**RE: Oakland Ridge Subdivision
Grading Plan and Drainage Report
Stamp Date: 6/27/17
Hydrology File: C18D085**

*Oakland Ridge Subdivision
Drainage Management Plan*

**Re: Oakland Ridge Subdivision
Engineers stamp date 6-27-17 (C18 /D085)**

**RE: Oakland Ridge Subdivision
Grading Plan and Drainage Report
Stamp Date: 5/19/17
Hydrology File: C18D085**

PROJECT Oakland Ridge
SUBJECT Lot 6 - Cross Section
BY Dtt DATE 6-26-17
CHECKED _____ DATE _____
SHEET _____ OF _____

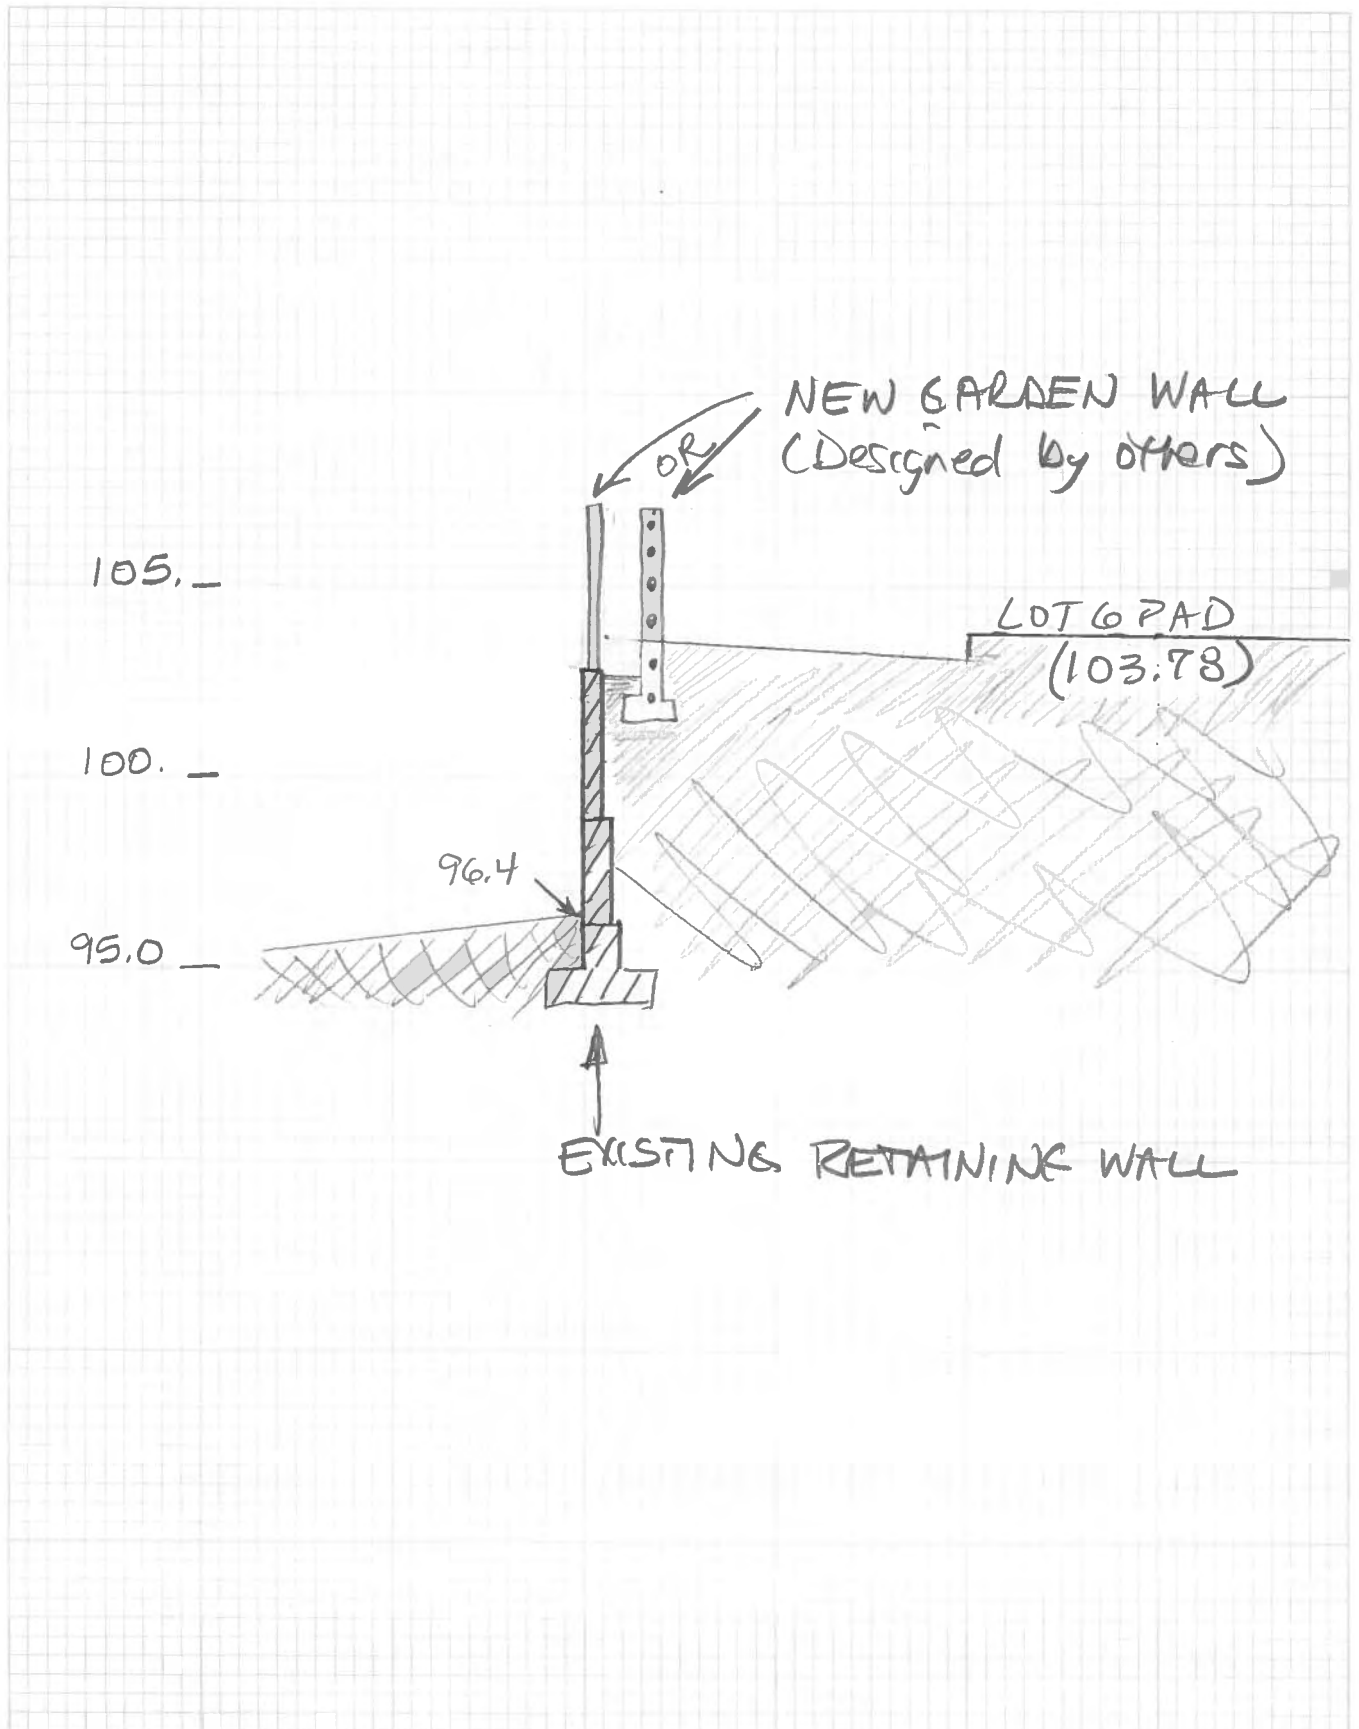
12. Along the northern half of the existing retaining wall along the western property line, starting at Lot 6 the proposed grades are higher than the top of the existing retaining wall. There are considerable constructability issues here. Please clarify and provide a cross section of the existing retaining wall.

12. *Yes the dirt will be about 12" higher than the top of the existing retaining wall. This is OK. A new fence will be constructed in accordance with current zoning ordinances. This will be designed by others.*

Tract A-Grate

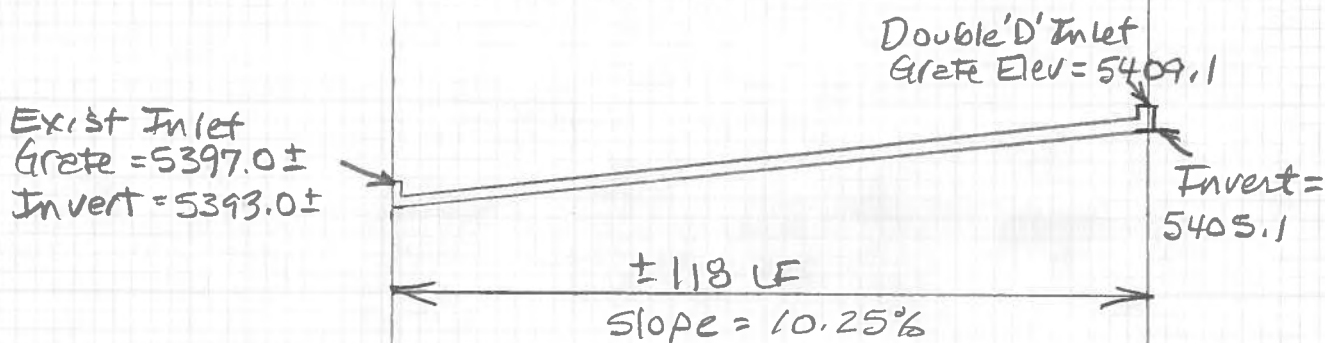
7. Please provide inlet capacity and weir calculations for the proposed Type A inlet.
8. Please provide the calculation for the 100 year HGL through the proposed 24" storm pipe from the existing inlet to the proposed Type A inlet.

8. Please show better line weight between the existing sidewalks & ramps and the proposed sidewalks & ramps.
9. Please provide the Grate elevation for the Type A inlet.
